Dantzic - Methodology for removal of existing lintels from level 9 windows - Full survey - Page 1 of 3

RCL DANTZIC HERITAGE MARK UP - 008 - FULL SURVEY

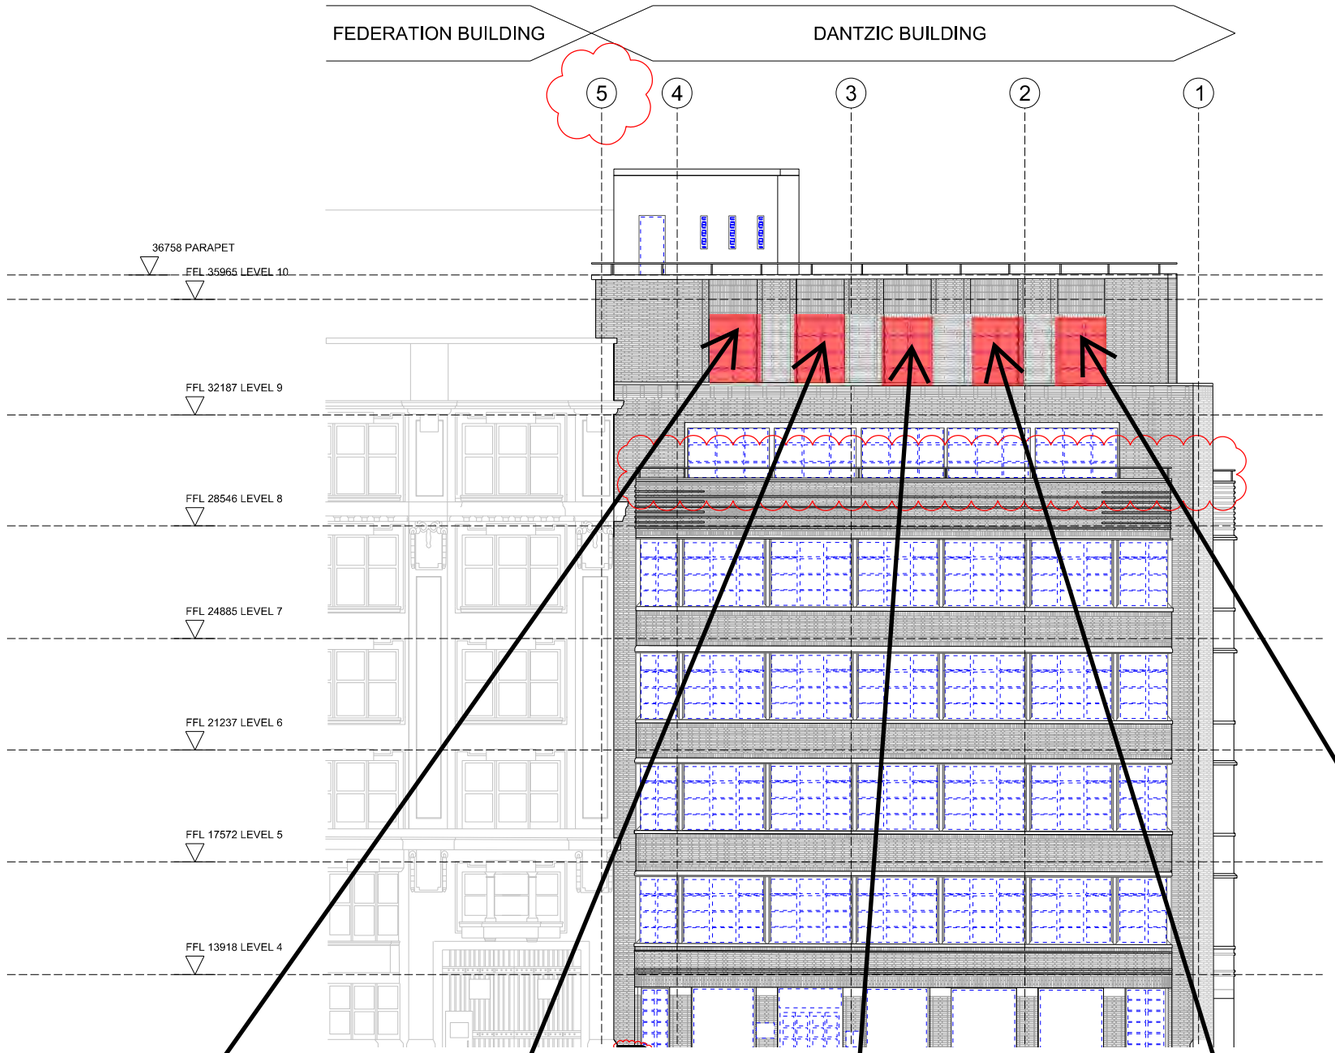
Window 9.01 - 20mm - Approx sag 7mm

Window 9.02 - 21mm - Approx sag 8mm

Window 9.03 - 16mm - Approx sag 3mm

Window 9.04 - 15mm - Approx sag 2mm

Window 9.05 - 15mm - Approx sag 2mm

Dantzic - Methodology for removal of existing lintels from level 9 windows - Full survey - Page 2 of 3

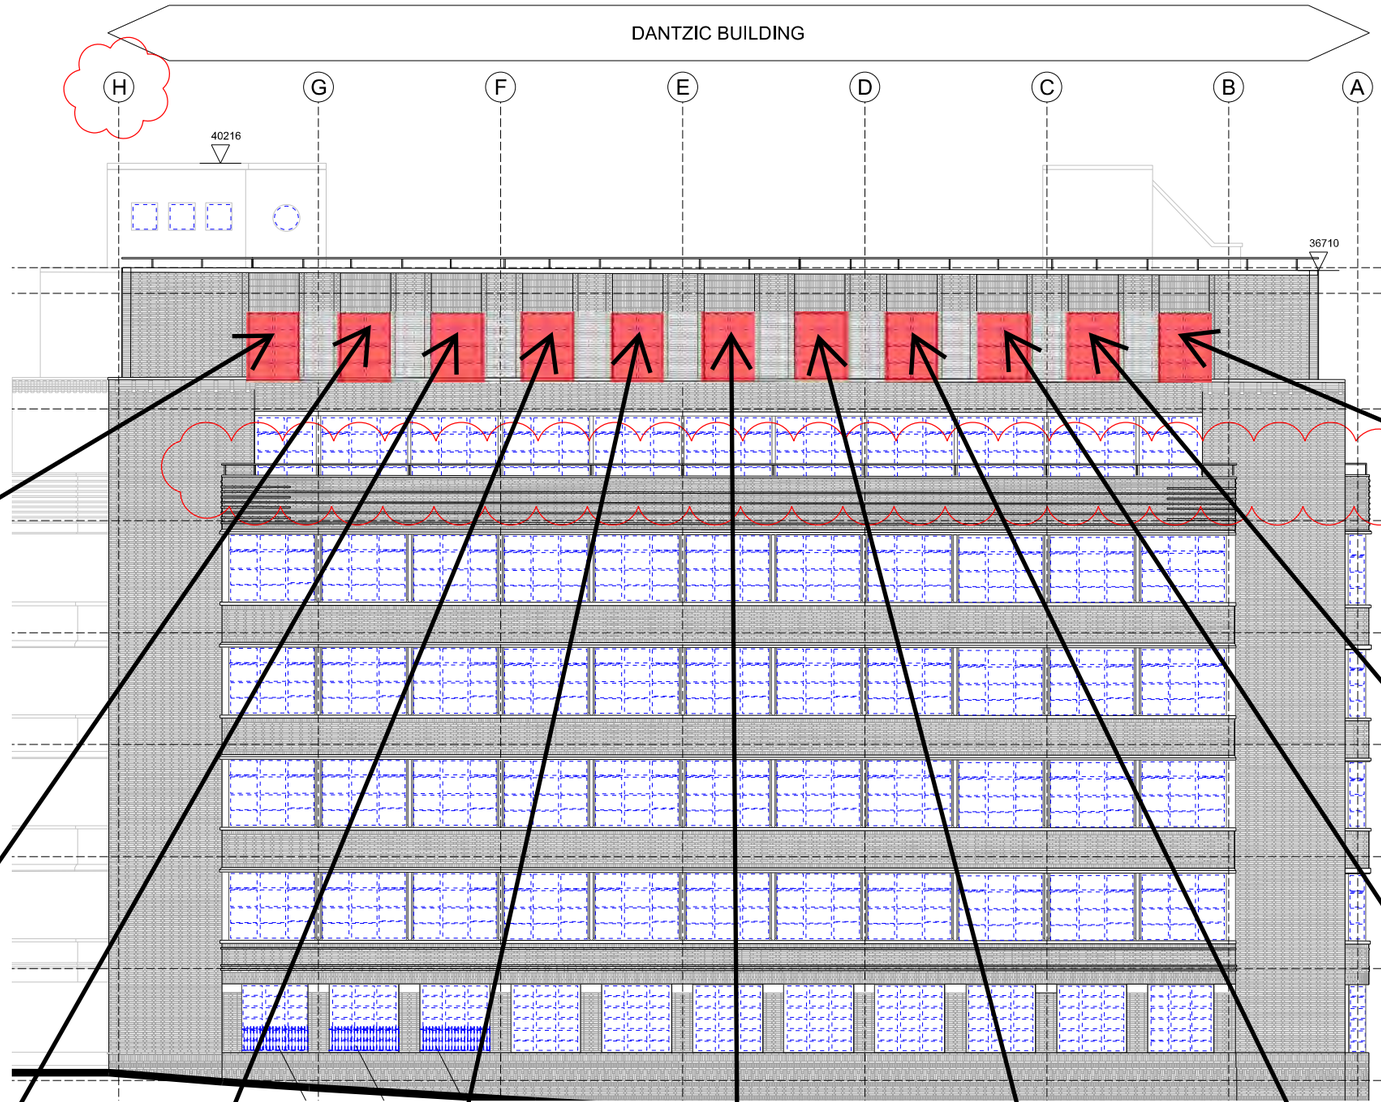
Window 9.06 - 17mm - Approx sag 4mm

Window 9.07 - 20mm - Approx sag 7mm

Window 9.08 - 30mm - Approx sag 17mm

Window 9.09 - 24mm - Approx sag 11mm

Window 9.10 - 20mm - Approx sag 7mm

Window 9.11 - 28mm - Approx sag 15mm

Window 9.12 - 24mm - Approx sag 11mm

Window 9.13 - 23mm - Approx sag 10mm

Window 9.14 - 22mm - Approx sag 9mm

Window 9.16 - 30mm - Approx sag 17mm

Window 9.15 - 26mm - Approx sag 13mm

Dantzic - Methodology for removal of existing lintels from level 9 windows **-** Full survey **-** Page 3 of 3

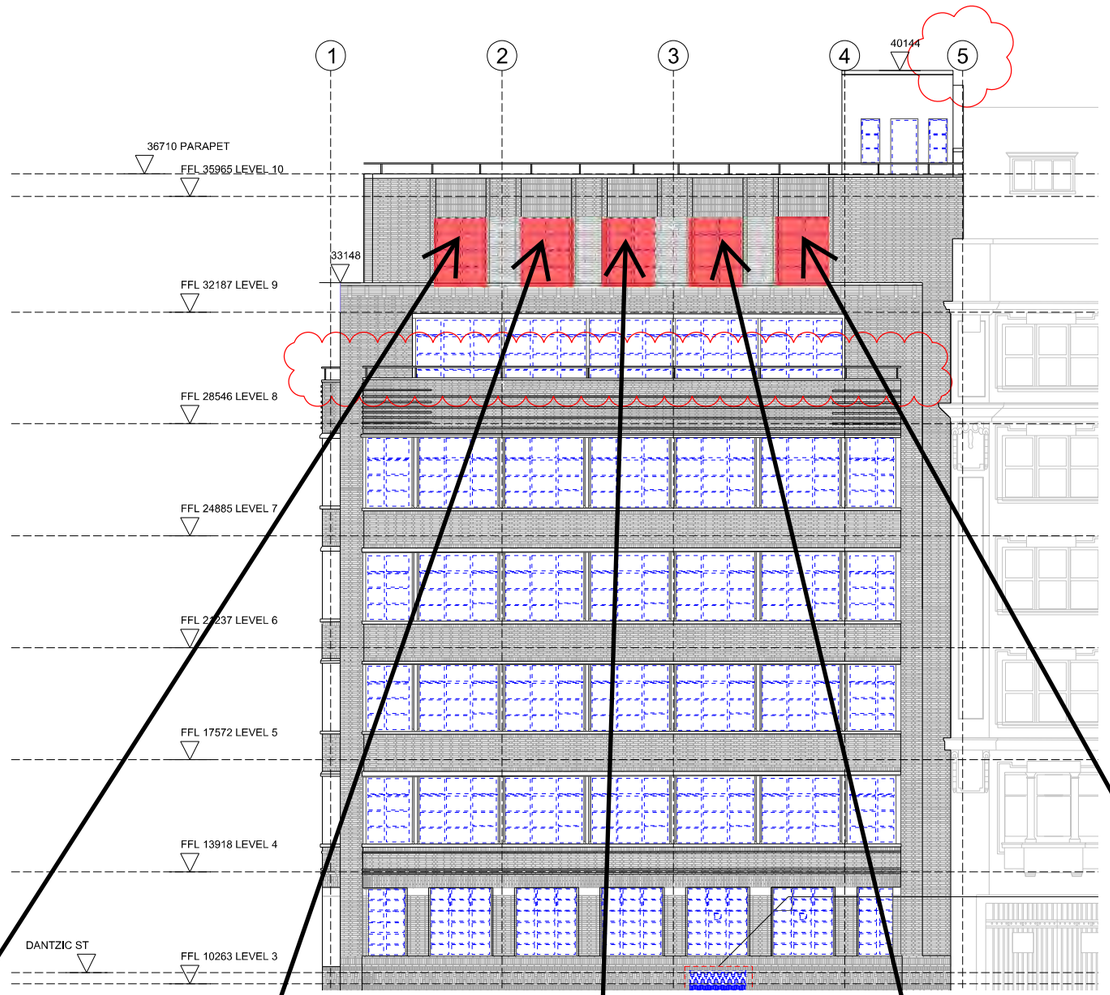
Window 9.17 - 20mm - Approx sag 7mm

Window 9.18 - 14mm - Approx sag 1mm

Window 9.19 - 23mm - Approx sag 10mm

Window 9.20 - 13mm - Approx sag 0mm

Window 9.21 - 14mm - Approx sag 1mm
